MEMORANDUM

TO: Chairman Durham and Planning Commissioners
FROM: Mike Craig, Senior Planner
DATE: March 17 for the March 22, 2023 meeting
RE: **RZFY23-01 Ideal Realty, LLC** request a rezoning from Planned Development-Medical Center (PD-MC) to Planned Development-Mixed Use (PD-MU), at 1500 Gateway Boulevard (GPIN 7769-93-9151, 7769-94-7825, 7779-02-1758, 7779-03-1528).

The project site outlined in Cyan.

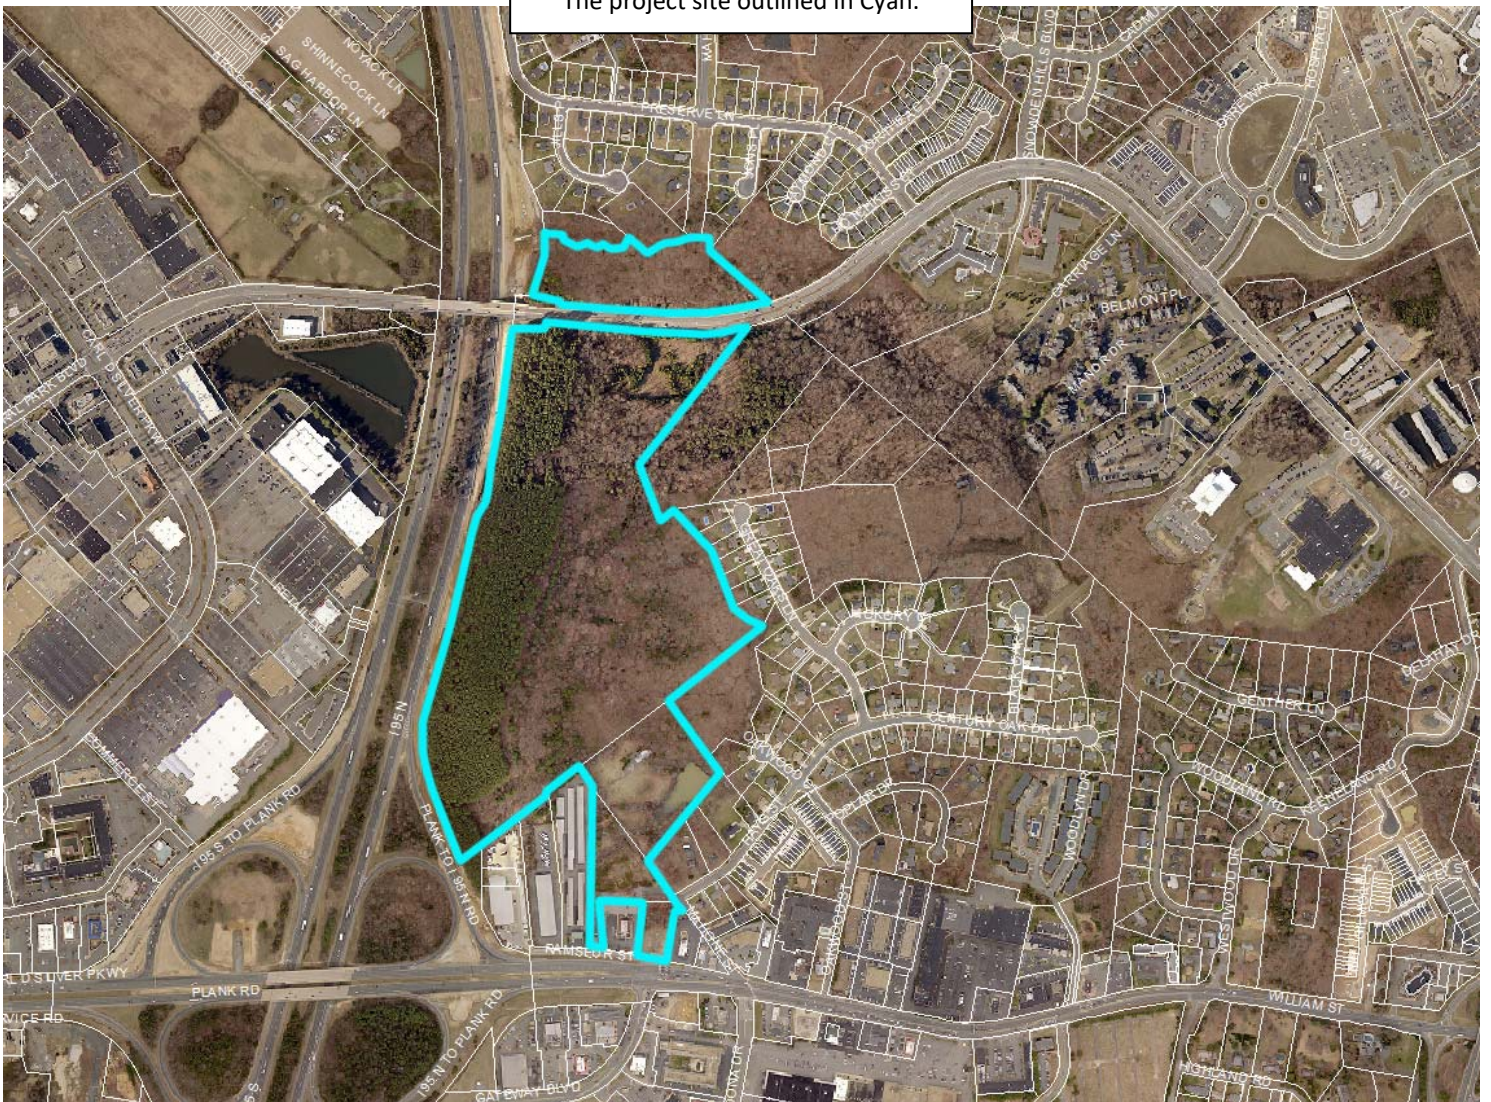
The land use and transportation concepts presented in the applicant's proposal align with the City's Comprehensive Plan in a broad sense. However, the structure of its proposal, the commitments in the proffer statement, the role of the Design Guidelines, and several details related to timing of construction vs. utility availability and stormwater infrastructure are currently insufficient to clearly show that the project will actually implement the proposed concept. This memo focuses on the technical details of the General Development Plan, Design Guidelines and identifies recommended modifications to those documents to ensure that the project documents produce the type of development that meets the Comprehensive Plan's goals.

No action is recommended for the Planning Commission and consideration of the application should be continued until its April 12 meeting.

Form Based Design Concept – “Additional Notes on T-5W and Adjoining T-4 in Area 3” (CP 11(3)-6).

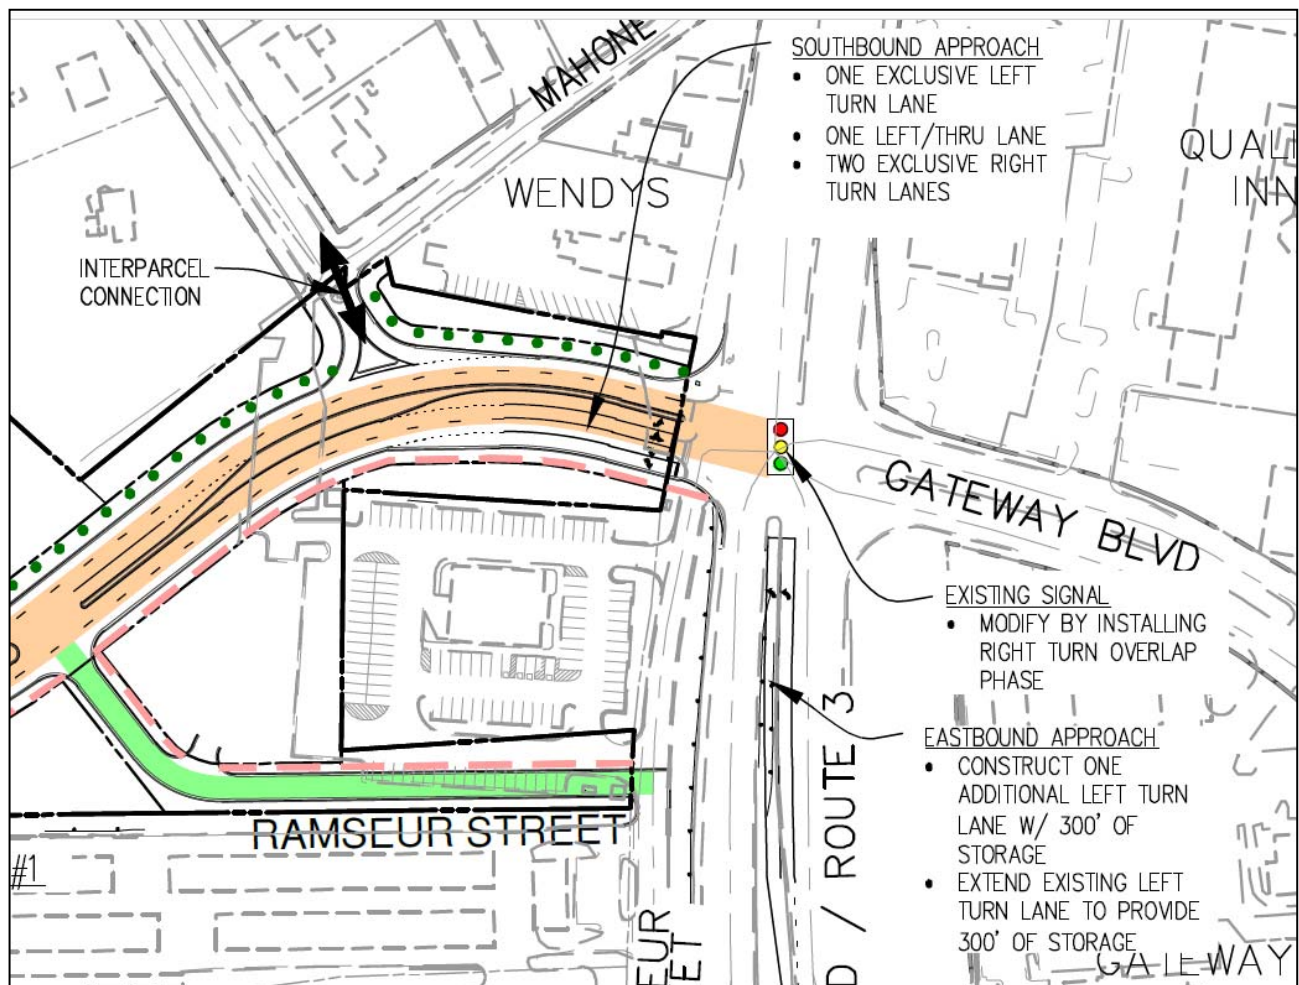
Comprehensive Plan Chapter 7: Residential Neighborhoods and Housing includes Goal 8, Variety of Housing and Goal 9, Homeownership. The diversity of unit types in the application and specifically the inclusion of use types that produce the opportunity for homeownership such as townhomes is a positive aspect of the application. The applicant should consider requiring that these unit types make up a minimum portion of the overall unit mix.
